Critical Area Determination

Staff Report and Decision

| Project No: | CAO17-007 (SEP18-021) |
| Project Description: | Request for approval of a critical areas determination in order to modify a steep slope and to install a stormwater drainage system within and across a watercourse and watercourse buffer associated with construction of a new single family residence. |

SPECIAL GEOTECHNICAL ULTRABLOCK NOTES

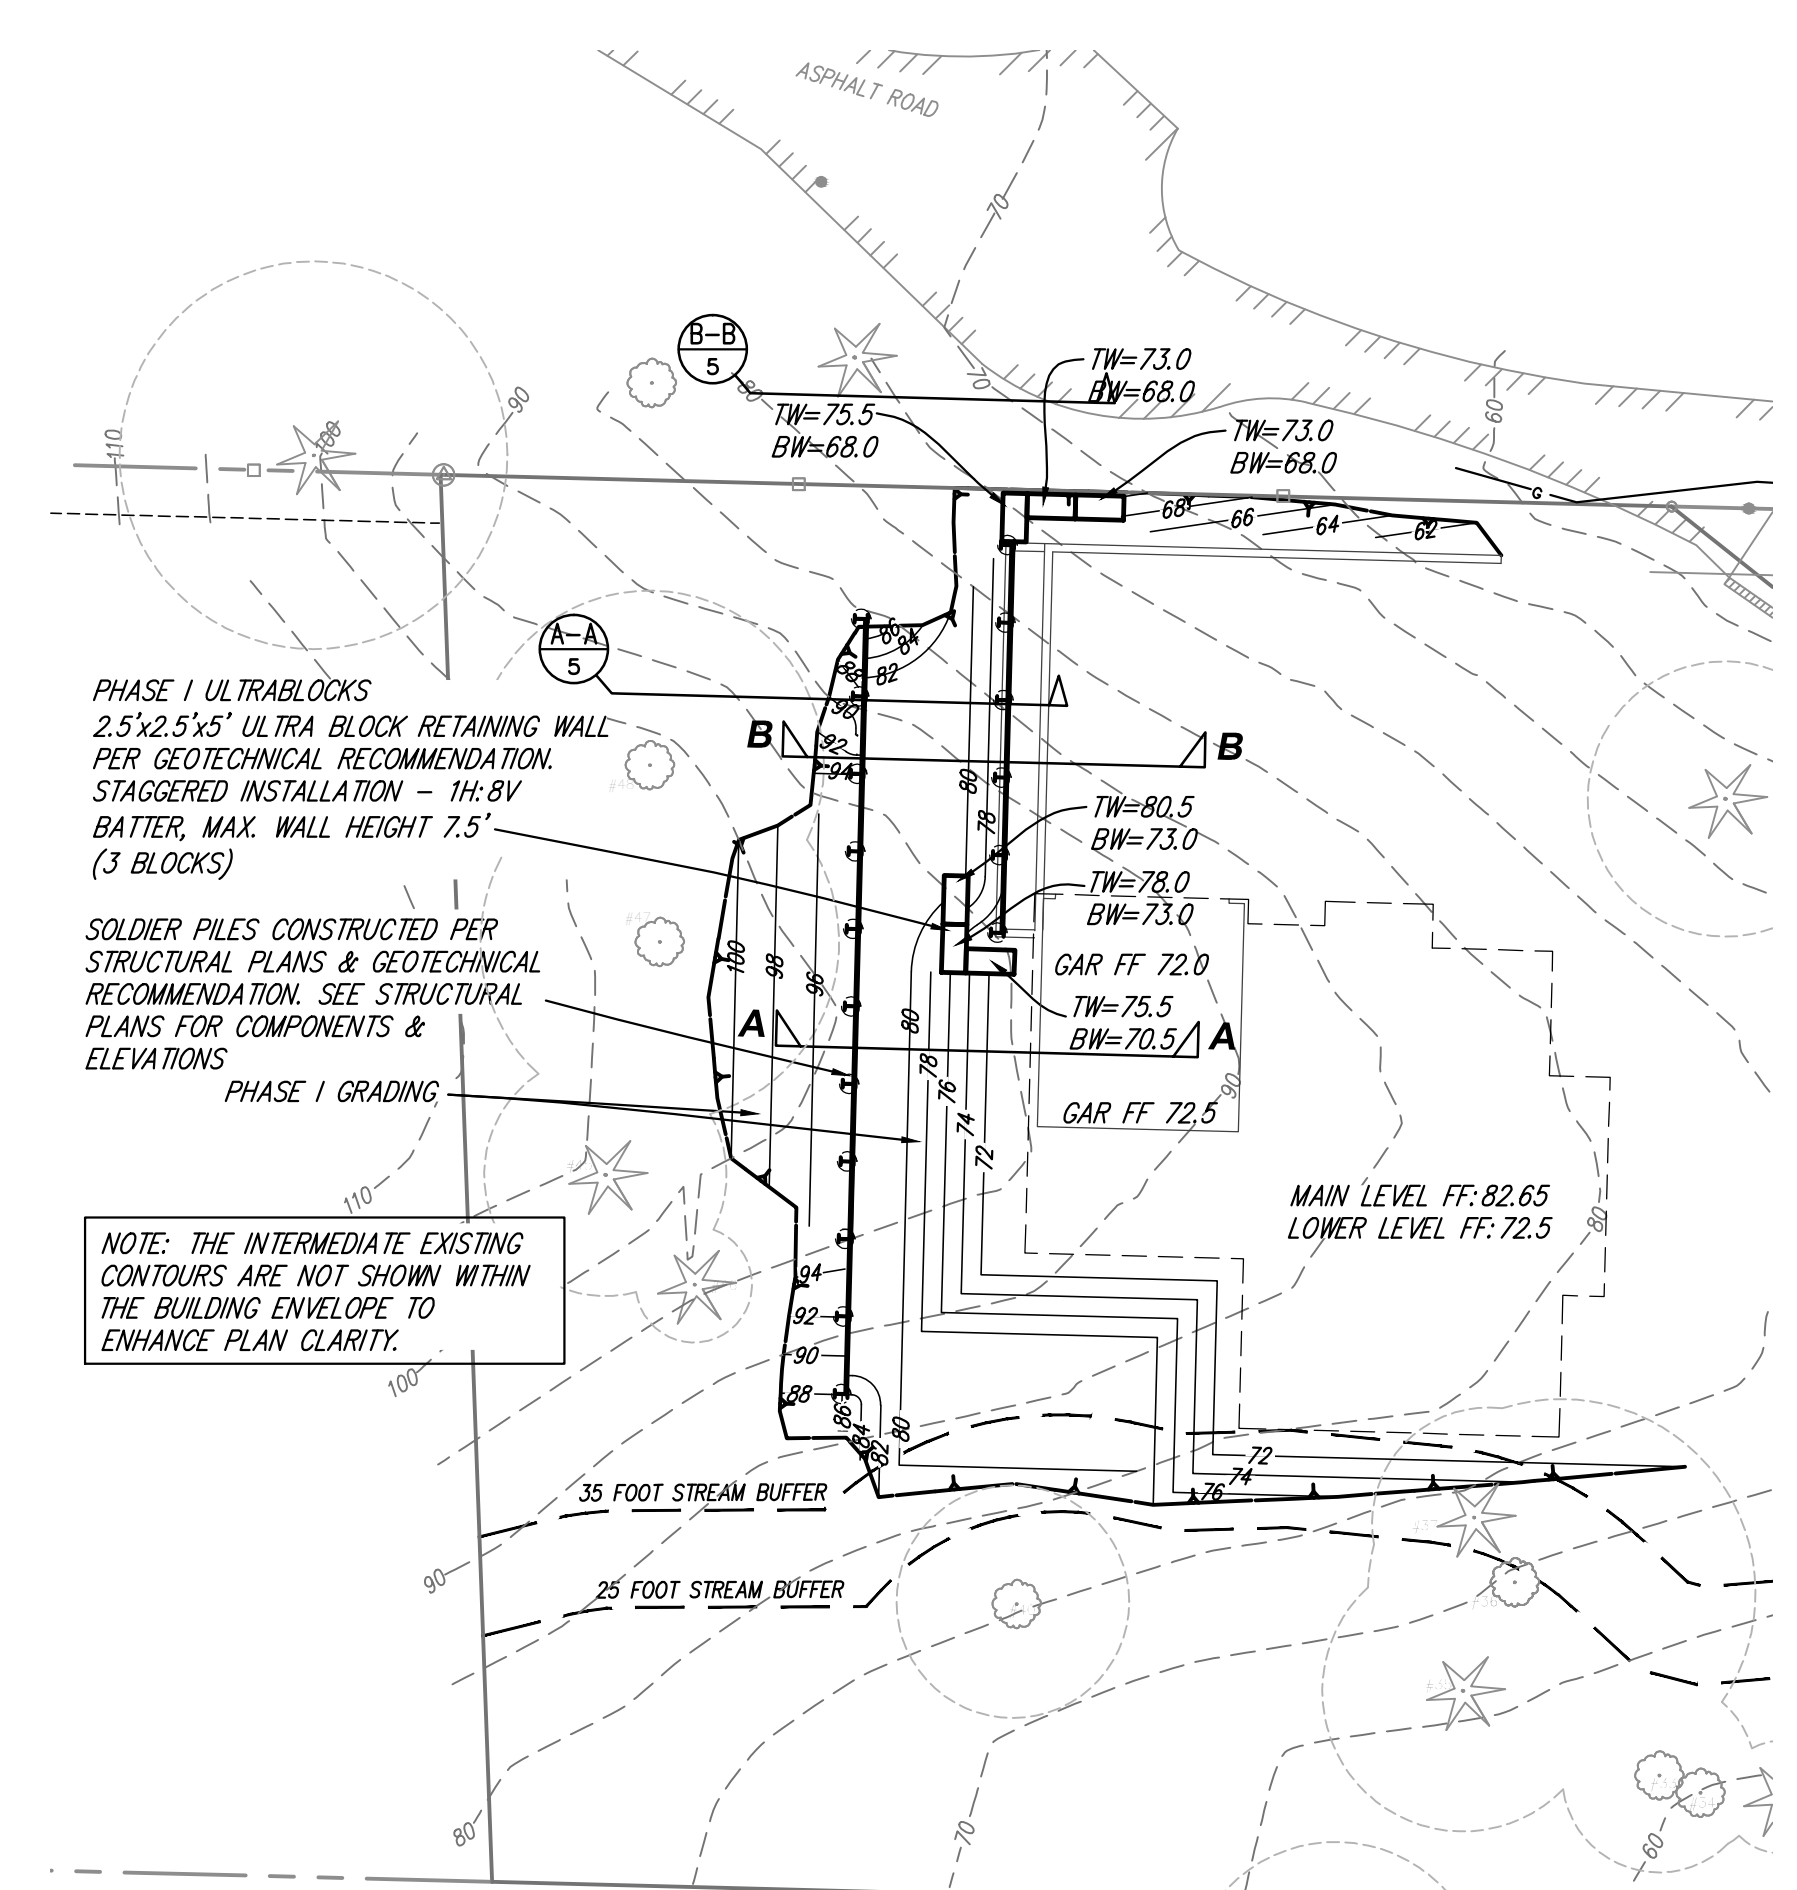
The temporary excavation plan on Sheet 5 of 6 by Litchfield Engineering last revised 8/3/2018, indicates a temporary 1H:1V cut in front of the soldier pile wall with a 5-foot wide bench in front of the wall. The structural drawing (S-11, by tecinstruct LLC, last revised 8/12/2016) does not indicate a bench. Whatever will be the worst-case condition (no bench) should be assessed for stability by the geotechnical engineer. If no bench is anticipated, the temporary excavation plan should also be revised.

Also, on Sheet 5 of 6 at the ends of the soldier pile wall, a permanent 1H:1V cut is indicated on the plans. The geotechnical engineer should provide specific permanent cut slope recommendations at these locations or the wall should be extended to reduce or eliminate the proposed cuts.

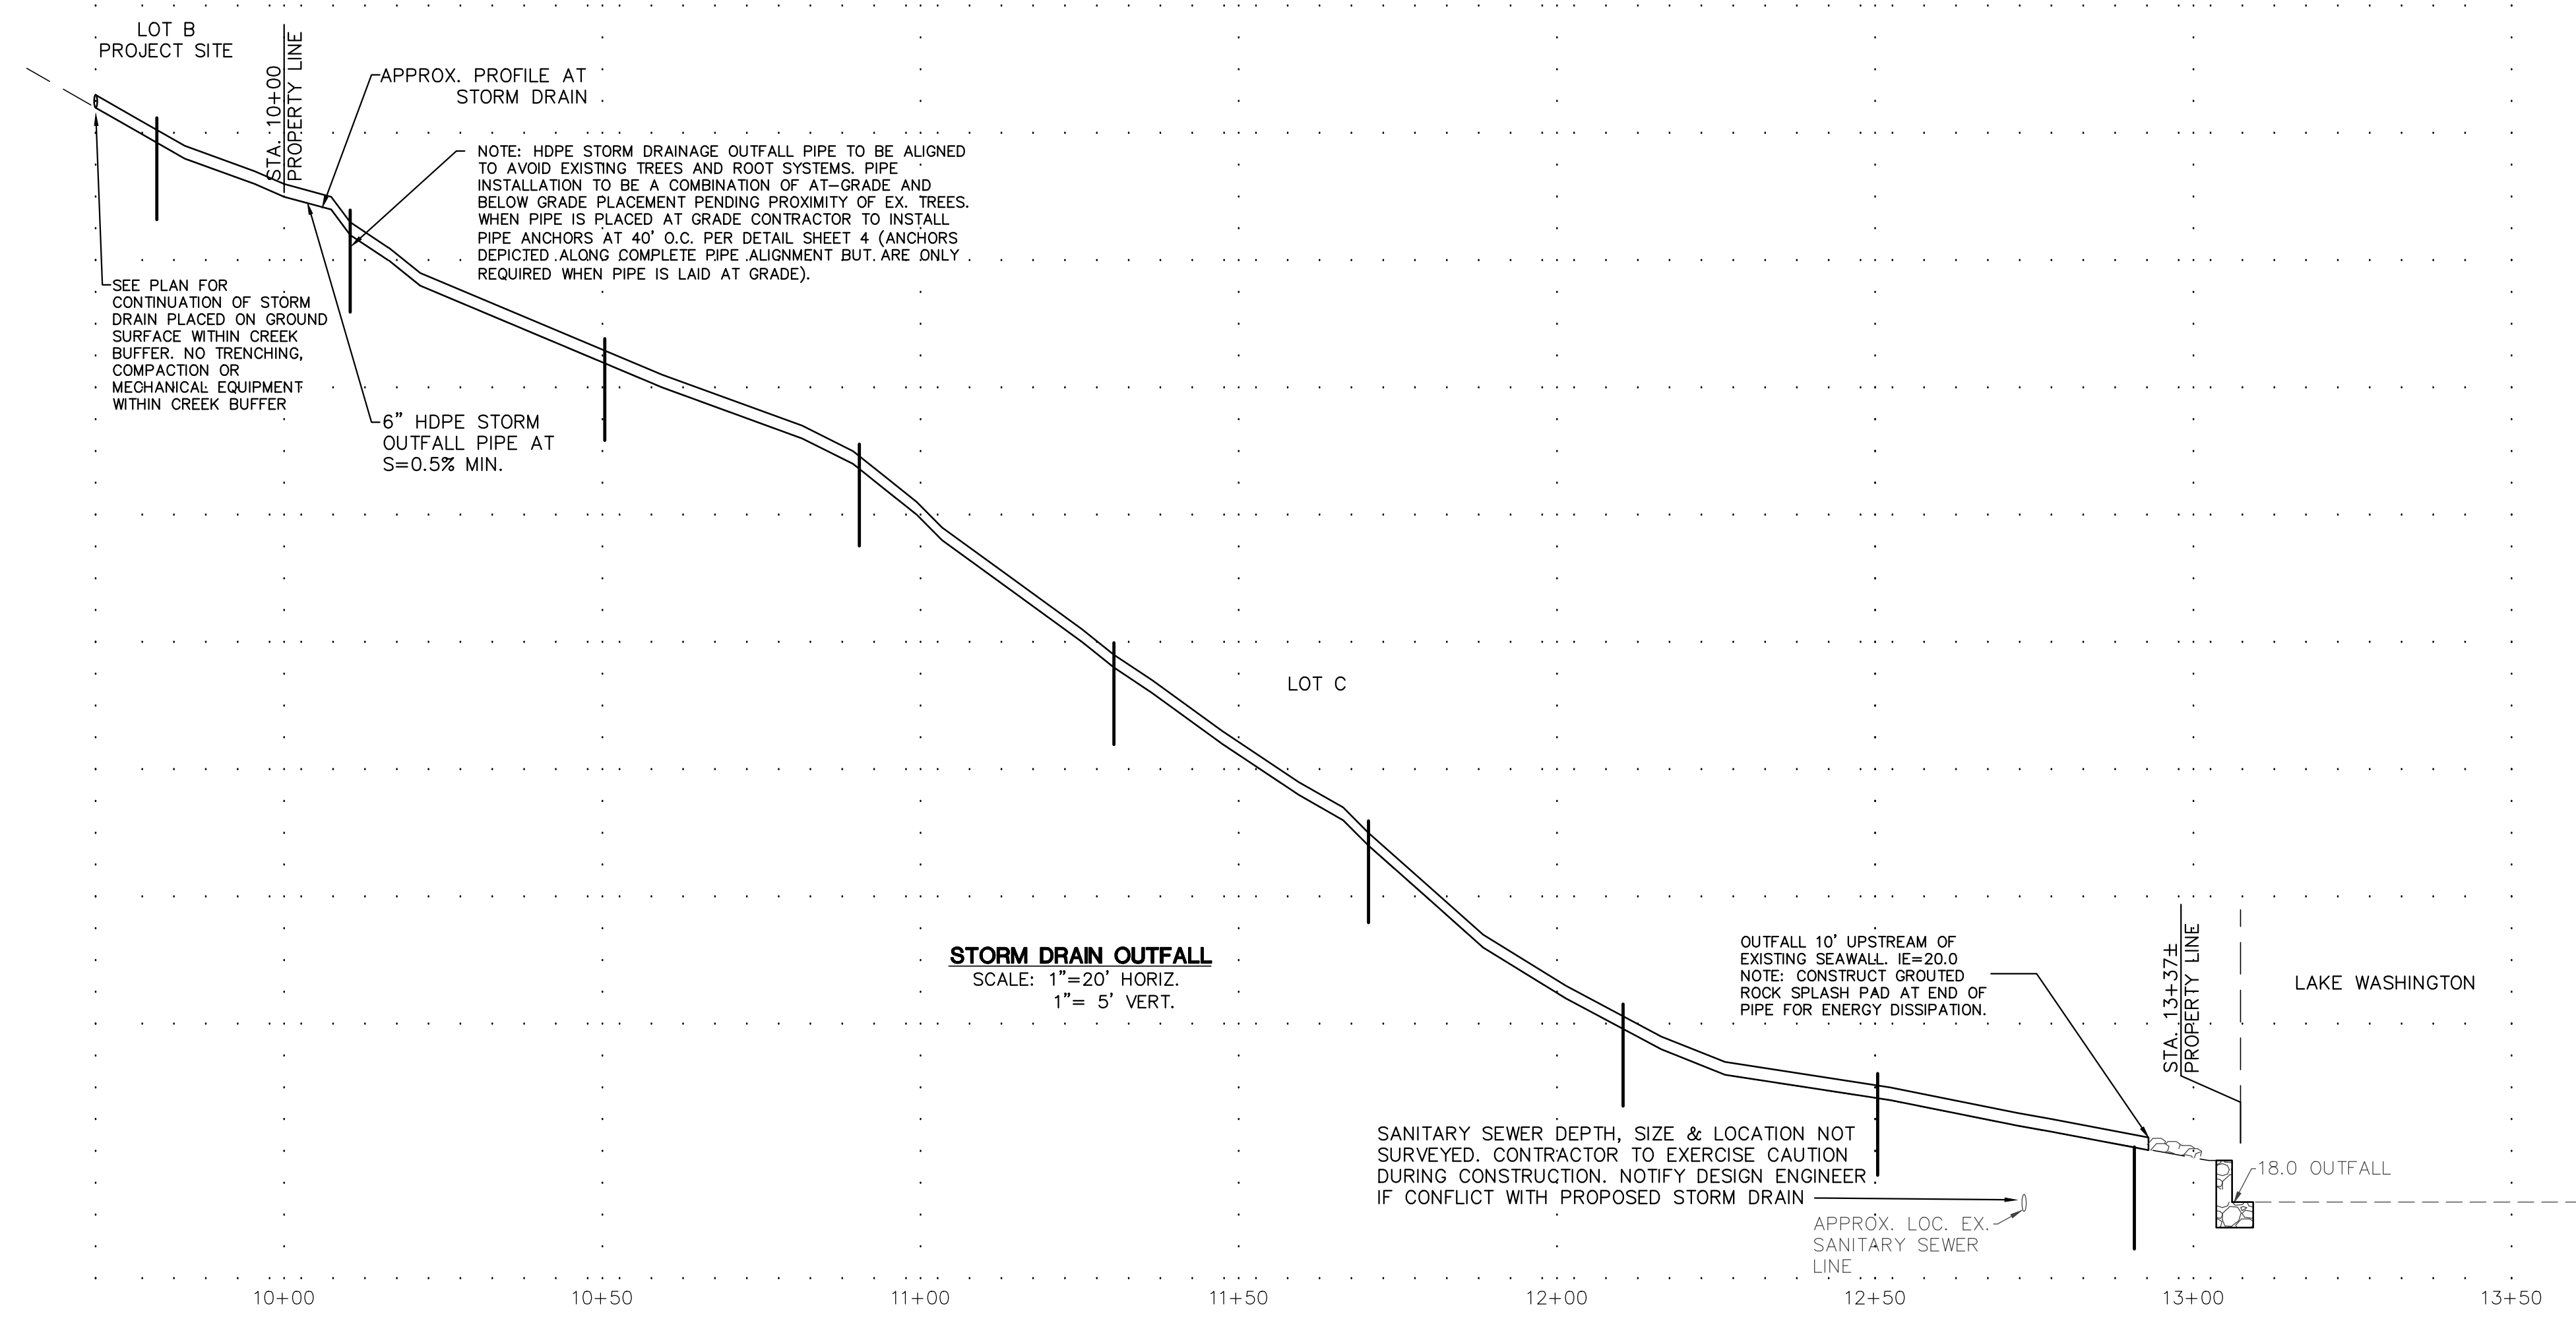
Staff response: The proposed tightline will be installed above ground, with pipe anchors placed to avoid trees (Exhibit 5). Existing vegetation within the watercourse buffer consists of English ivy and maintained lawn (Exhibit 11) causing minimal impact to ecological functions and values. No mitigation is proposed. The applicant's critical area study was reviewed by the City's peer review, who confirmed that no mitigation is necessary for this scope of work (Exhibit 12).
